Duke Power Company

Oconee Nuclear Station

Attachment 1

Proposed Technical Specification Revision

Figure 2.1-2C.

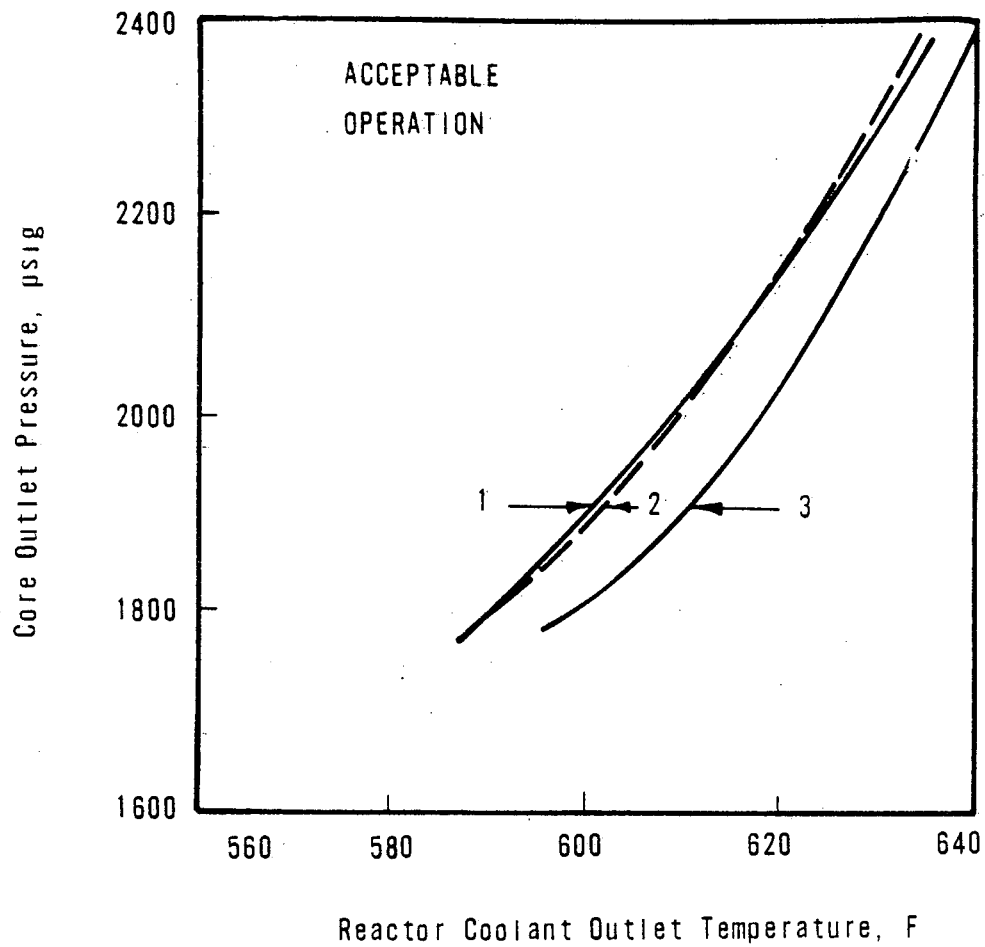
The specified flow rates for Curves 1, 2 and 3 of Figure 2.1-2C correspond to the expected minimum flow rates with four pumps, three pumps and one pump in each loop, respectively.

Figure 2.1-3C

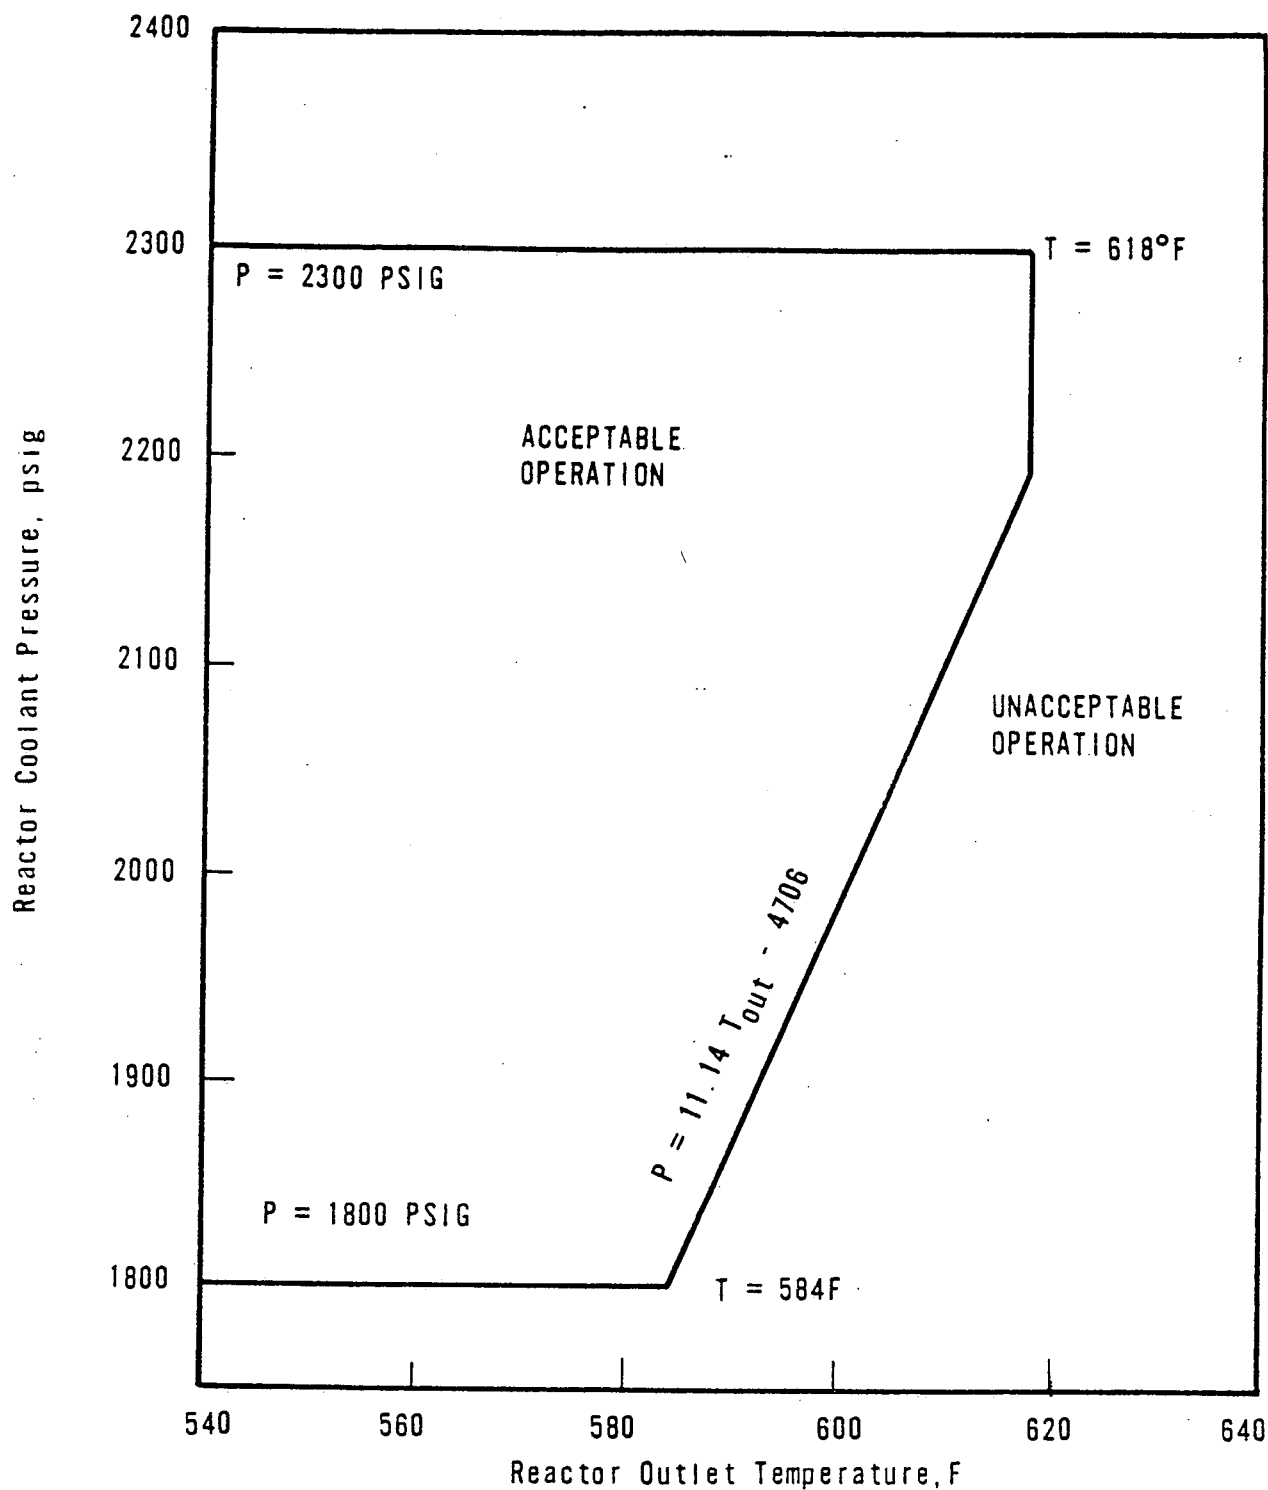
The maximum thermal power for three-pump operation is 90.65 percent due to a power level trip produced by the flux-flow ratio  $74.7 \text{ percent flow} \times 1.08 = 80.7 \text{ percent power}$  plus the maximum calibration and instrument error (Reference 4). The maximum thermal power for other coolant pump conditions are produced in a similar manner.

For each curve of Figure 2.1-3C a pressure-temperature point above and to the left of the curve would result in a DNBR greater than 1.30 or a local quality at the point of minimum DNBR less than 22 percent for that particular reactor coolant pump situation. The curve of Figure 2.1-1C is the most restrictive of all possible reactor coolant pump-maximum thermal power combinations shown in Figure 2.1-3C.

Figure 2.3-1 A

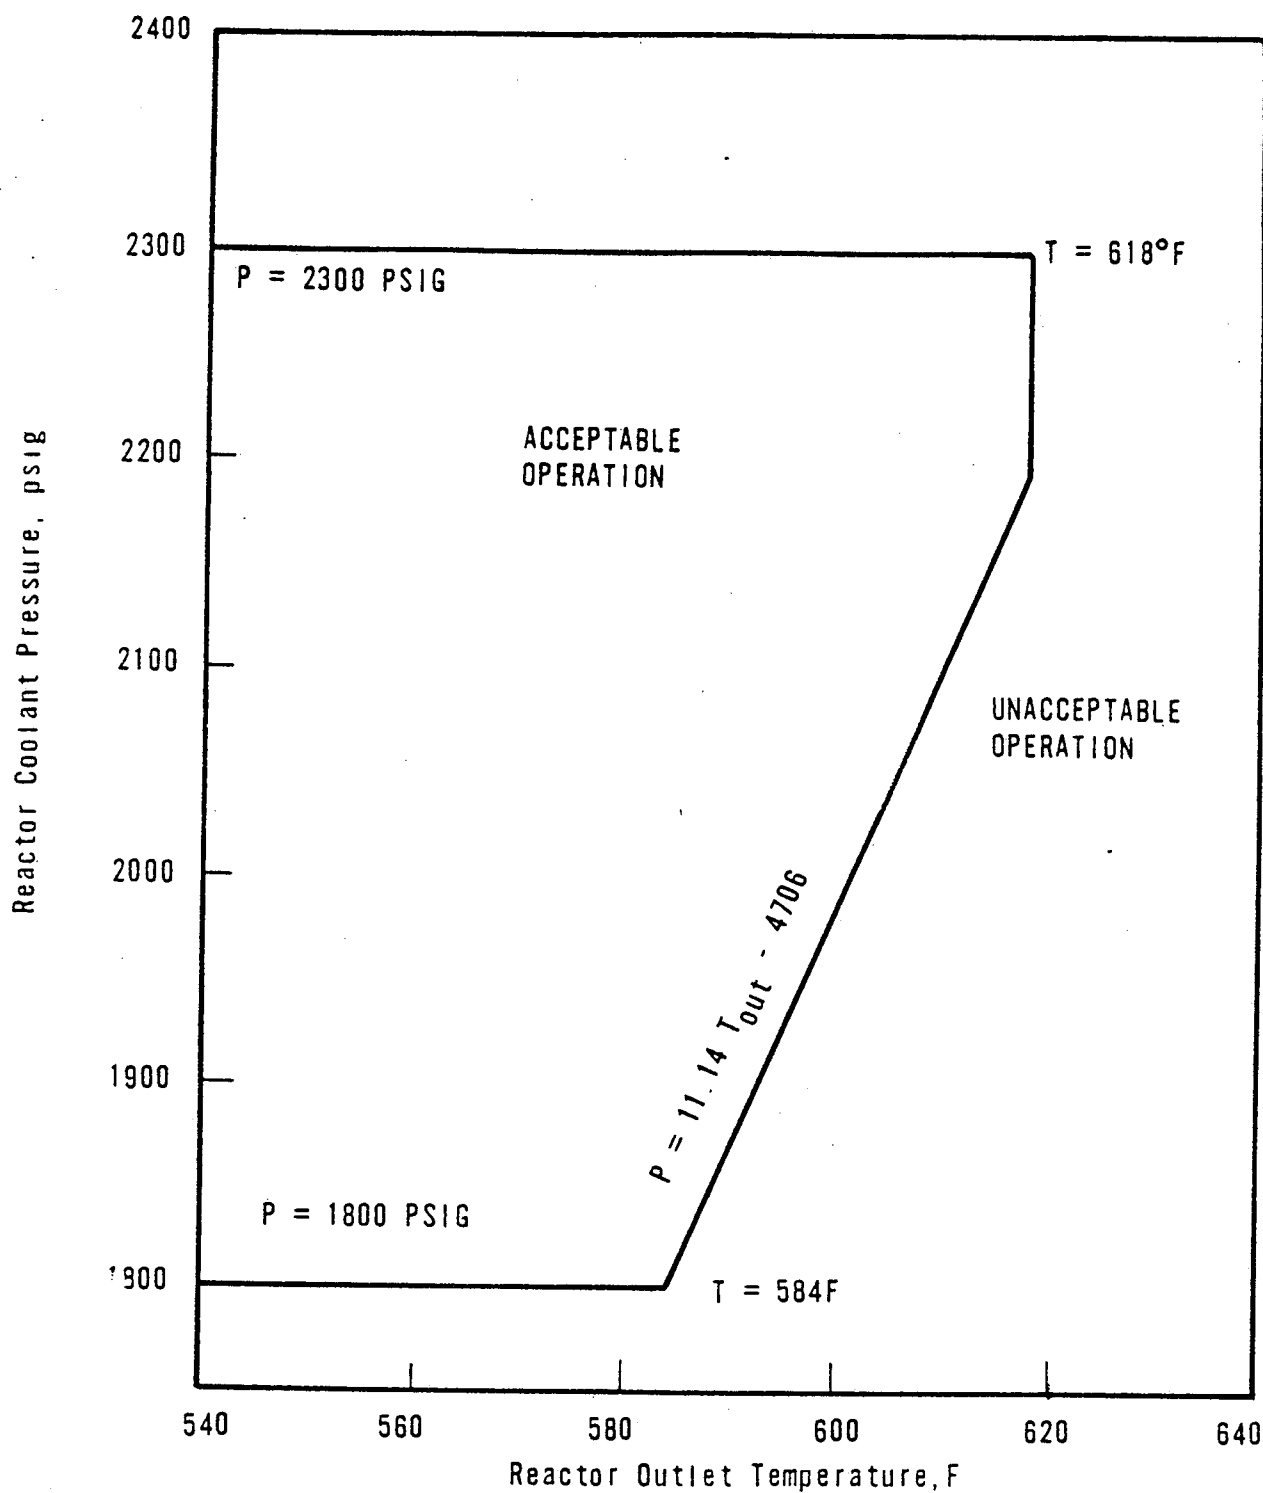
During a startup accident from low power or a slow rod withdrawal from high power, the system high pressure setpoint is reached before the nuclear over-power trip setpoint. The trip setting limit shown in Figure 2.3-1A - Unit 1

for high reactor coolant system pressure (2355 psig) has been established to maintain the system pressure below the safety limit (2750 psig) for any design transient. (1)

The low pressure (1800) psig and variable low pressure (11.14 T<sub>out</sub> - 4706) trip (1800) psig (11.14 T<sub>out</sub> - 4706) (1800) psig (11.14 T<sub>out</sub> - 4706)

setpoints shown in Figure 2.3-1A have been established to maintain the DNB

Figure 2.3-2C

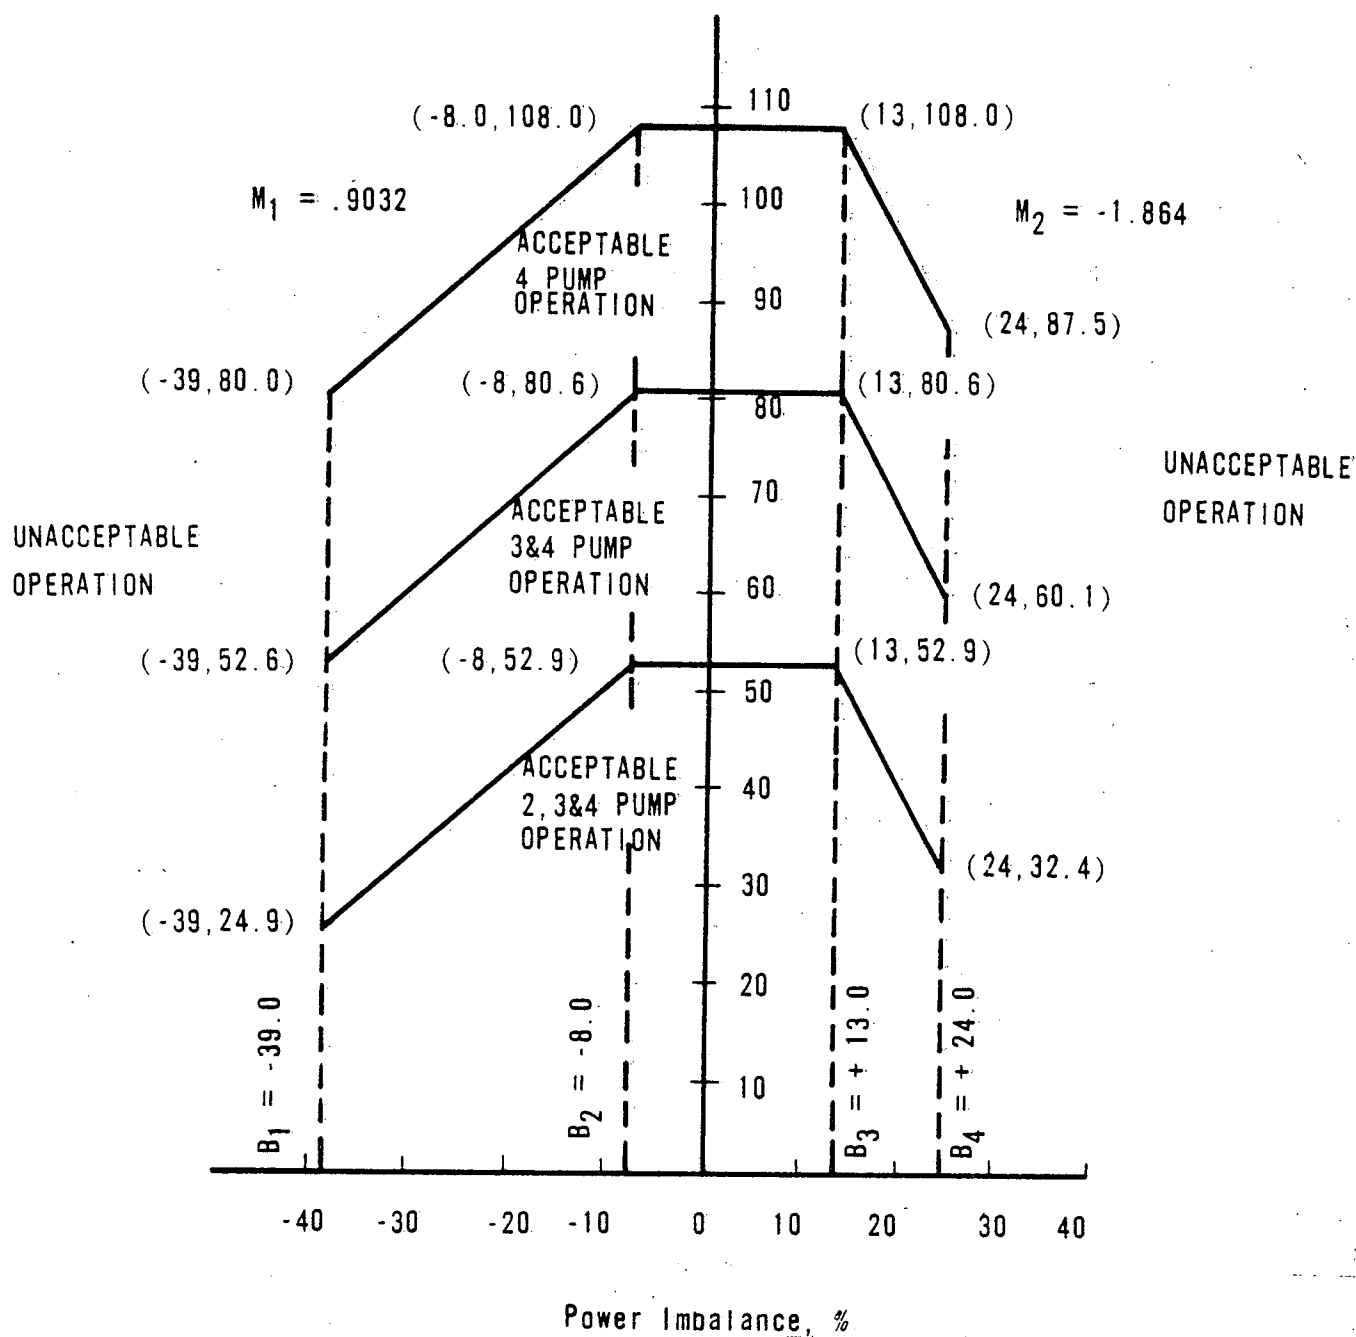
The power-imbalance boundaries are established in order to prevent reactor thermal limits from being exceeded. These thermal limits are either power peaking kw/ft limits or DNBR limits. The reactor power imbalance (power in the top half of core minus power in the bottom half of core) reduces the power level trip produced by the power-to-flow ratio such that the boundaries of Figure 2.3-2A - Unit 1 are produced. The power-to-flow ratio reduces the power

2.3-2B - Unit 2  
2.3-2C - Unit 3

level trip and associated reactor power/reactor power-imbalance boundaries by 1.08% - Unit 1 for 1% flow reduction.
